SILVERADO RANCH FILING NO. 2

Construction Drawings El Paso County, Colorado

TITLE SHEET

TYPICAL RURAL LOCAL ROADWAY SECTION (PRIVATE) (A)

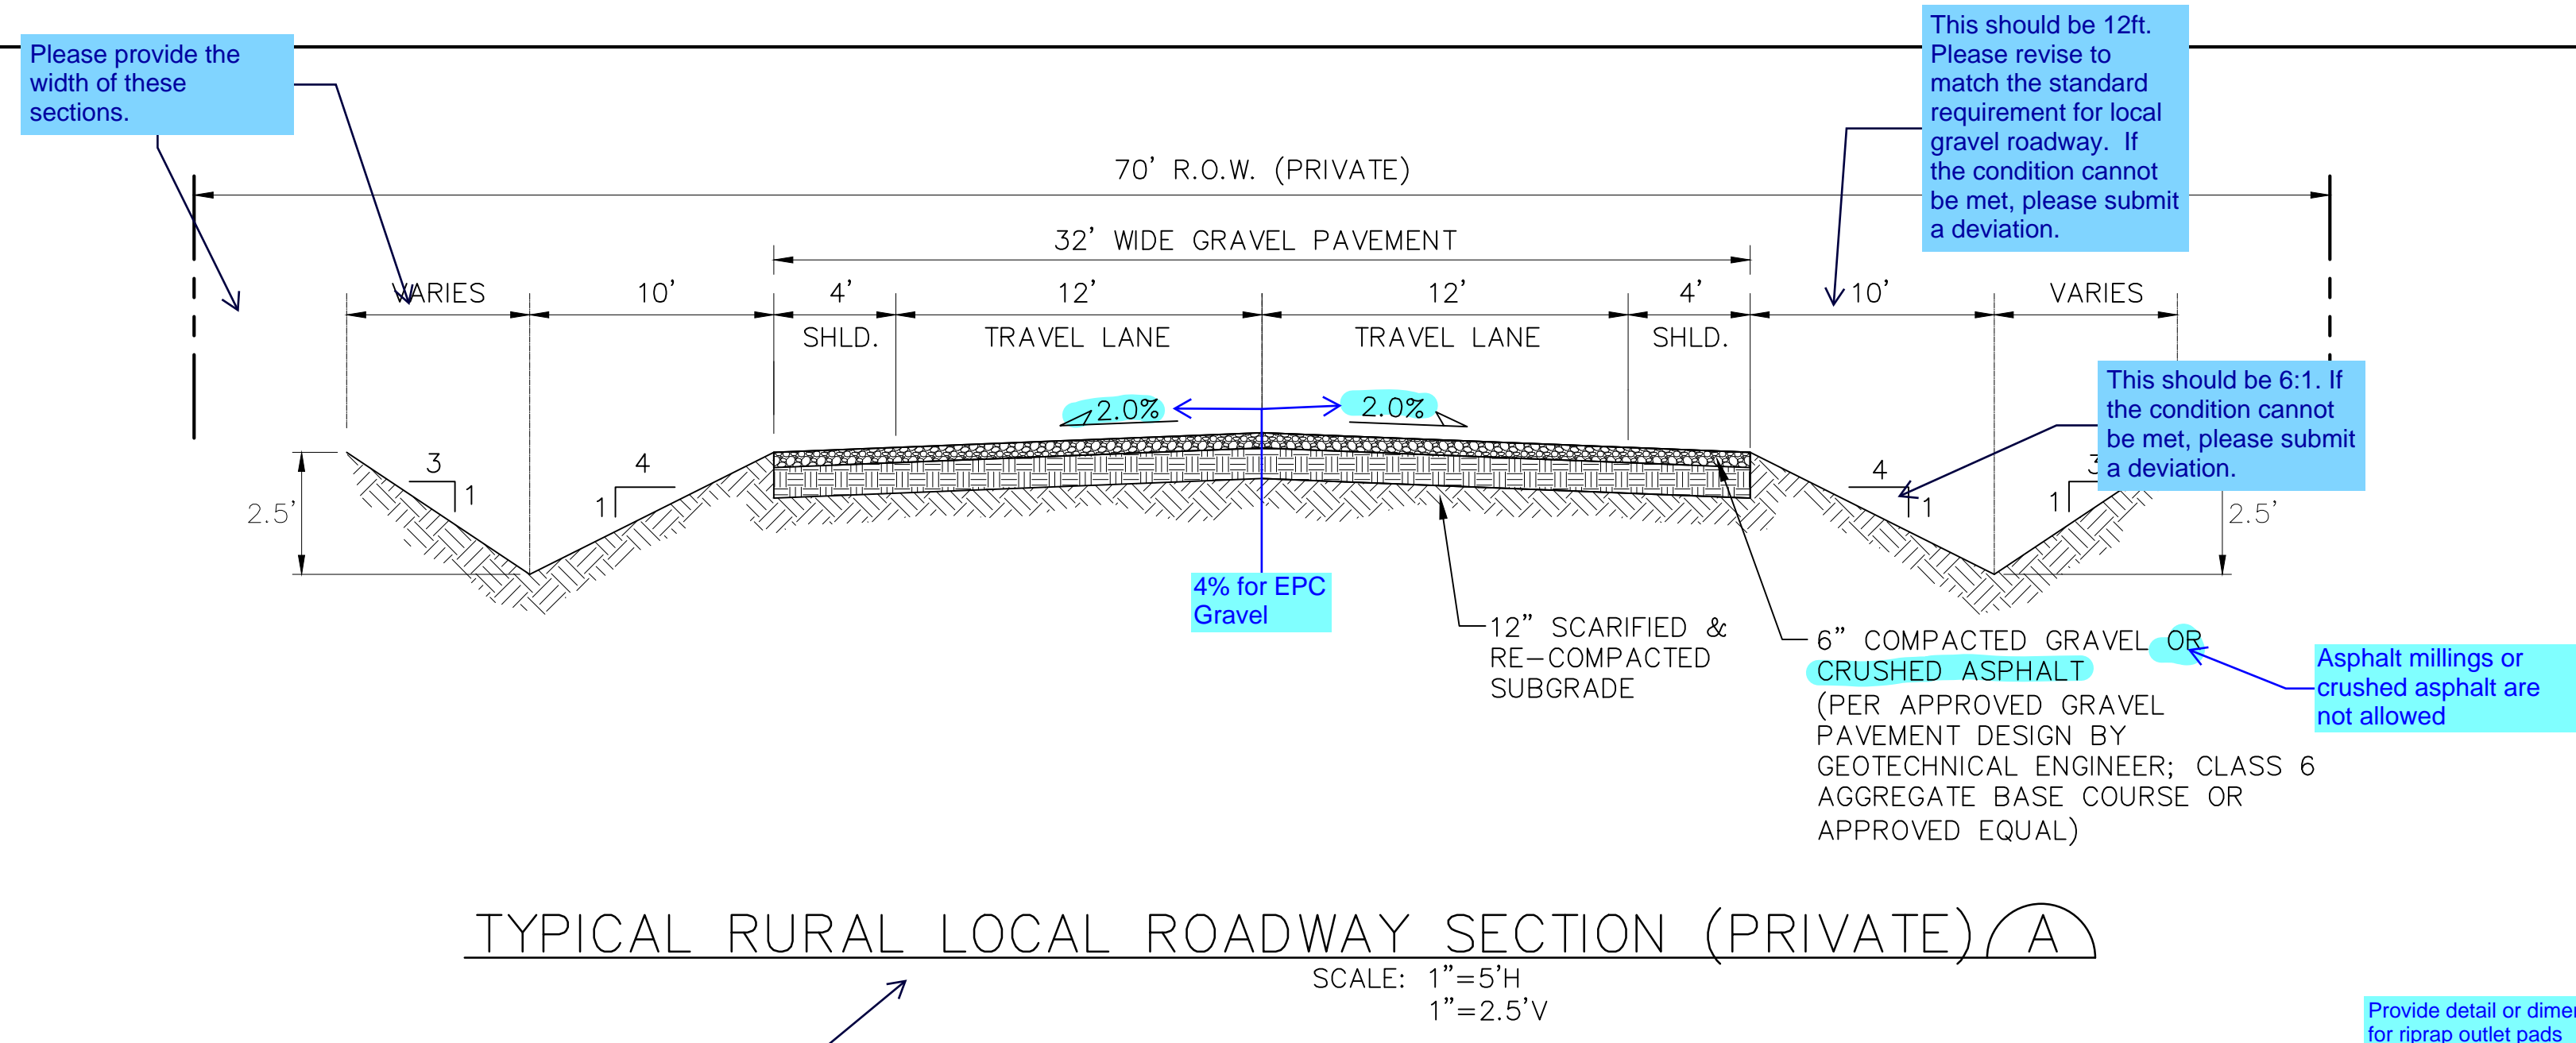
Please label it is gravel local roadway

TYPICAL DITCH SECTION WITH EROSION CONTROL BLANKET LINING (B)
SCALE : NTS

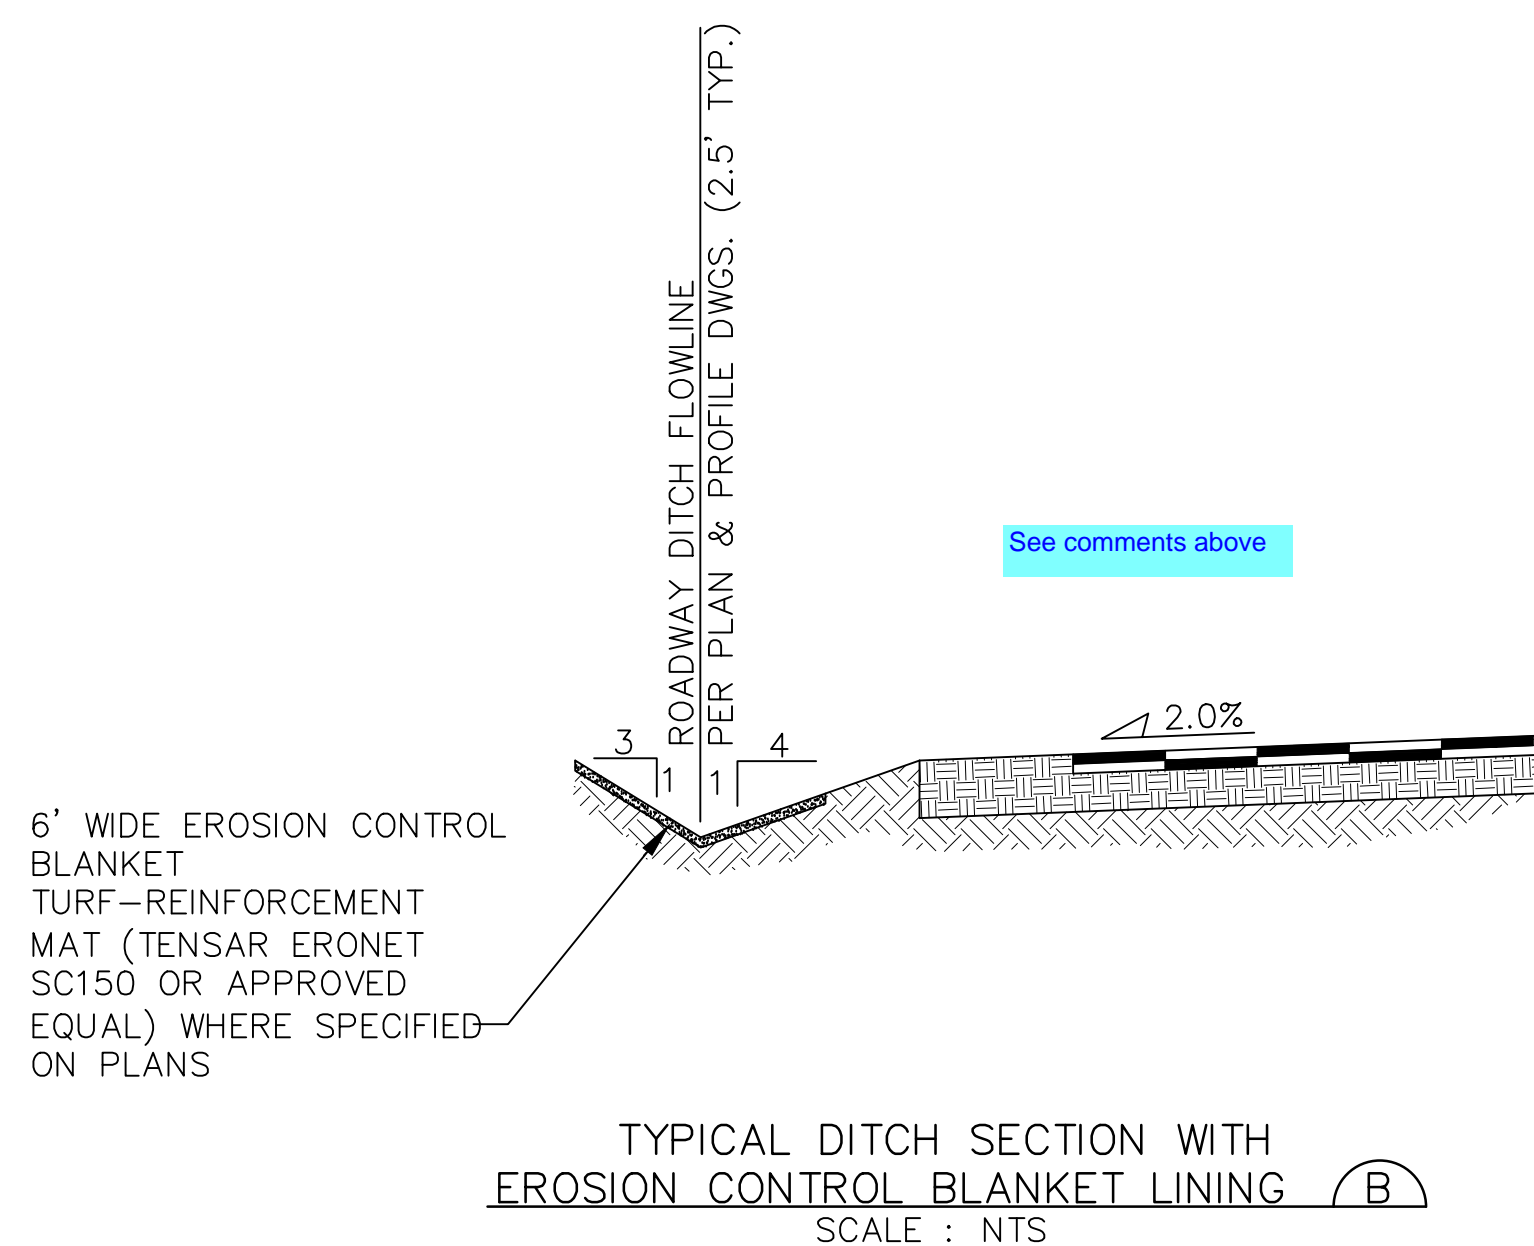
Provide detail or dimensions for riprap outlet pads

Provide sections for channel B1.1 & B4.1
